Dresden Nuclear Power Station, Units 2 and 3
Renewed Facility Operating License Nos. DPR-19 and DPR-25
NRC Docket Nos. 50-237 and 50-249

Subject: Fifth Six-Month Status Report in Response to March 12, 2012 Commission Order Modifying Licenses with Regard to Reliable Spent Fuel Pool Instrumentation (Order Number EA-12-051)

**Fifth Six-Month Status Report for the Implementation of Order EA-12-051, Order
Modifying Licenses with Regard to Reliable Spent Fuel Pool Instrumentation**

Attachment 1: Plan View of Spent Fuel Pool Area

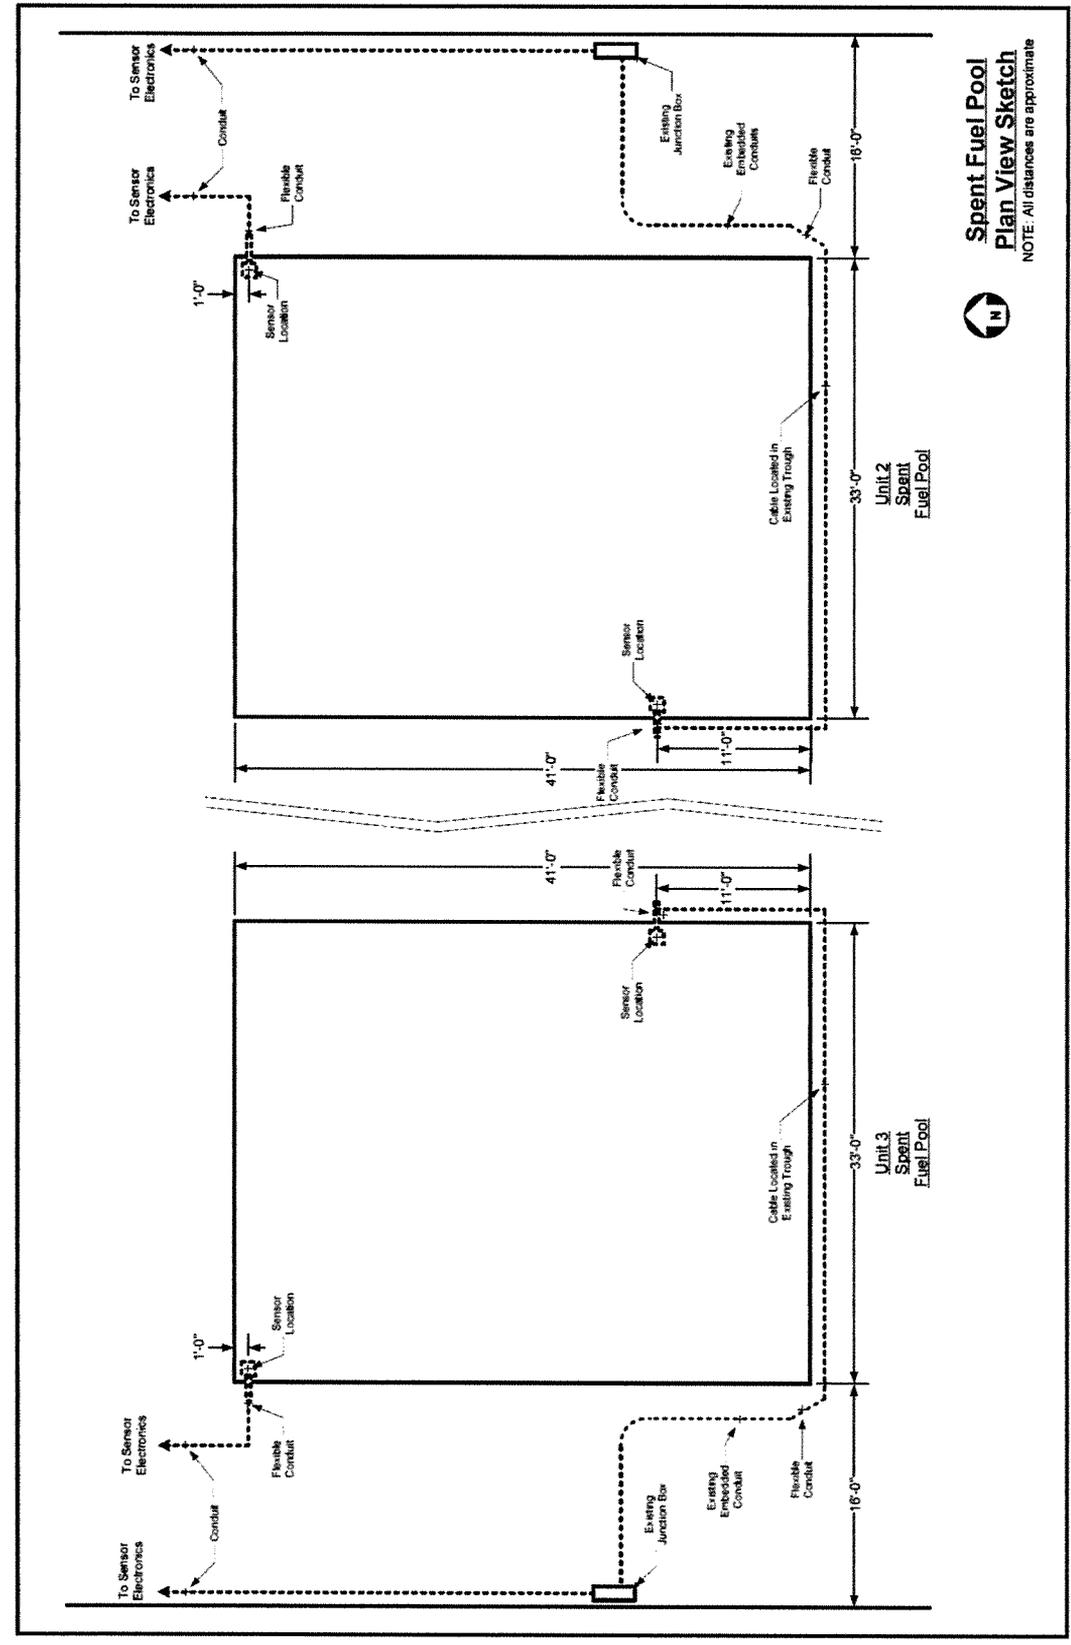
sensitive to measurement of the fuel pool level, with respect to the Level 1, Level 2, and Level 3 datum points.	
3 (RAI-2, Ref.3)	<p><u>RAI Question:</u></p> <p>Please provide a clearly labeled sketch or marked-up plant drawing of the plan view of the SFP area, depicting the SFP inside dimensions, the planned locations/placement of the primary and back-up SFP level sensor, and the proposed routing of the cables that will extend from the sensors toward the location of the read-out/display device.</p>	<p>Complete</p> <p>See Attachment 1 for the requested sketch. The cable routing has been updated to achieve maximum practical separation between the two channel coax cables in the refuel floor area.</p>
4 (RAI-3, Ref.3)	<p><u>RAI Question:</u></p> <p>Please provide the following:</p> <p>a) The design criteria that will be used to estimate the total loading on the mounting device(s), including static weight loads and dynamic loads. Describe the methodology that will be used to estimate the total loading, inclusive of design basis maximum seismic loads and the hydrodynamic loads that could result from pool sloshing or other effects that could accompany such seismic forces.</p> <p>b) A description of the manner in which the level sensor (and stilling well, if appropriate) will be attached to the refueling floor and/or other support structures for each planned point of attachment of the probe assembly.</p> <p>Indicate in a schematic the portions of the level sensor that will serve as points of attachment for mechanical/mounting or</p>	<p>Complete</p> <p>a) All SFPIS equipment will be designed in accordance with the Dresden Station Safe Shutdown Earthquake (SSE) design requirements.</p> <p>The vendor, Westinghouse, has evaluated the structural integrity of the mounting brackets in Calculation CN-PEUS-14-20 Pool-side Bracket Seismic Analysis. The GTSTRUDL model, proposed by Westinghouse to calculate the stresses in the bracket assembly, considers load combinations for the dead load, live load and seismic load on the bracket. The reactionary forces calculated from these loads will become the design inputs to design the mounting bracket anchorage to the refuel floor to withstand a Safe Shutdown Earthquake (SSE).</p> <p><u>Seismic</u></p> <p>The seismic loads were obtained from Dresden Station's response spectra curves (Reference TDBD-DQ-1 for Dresden Nuclear Generating Station). The following methodology was used in determining the stresses on the bracket assembly:</p> <ul style="list-style-type: none"> • Frequency analysis, taking into account the dead weight and the hydrodynamic mass of the structure, is performed to obtain the natural frequencies of the structure in all three
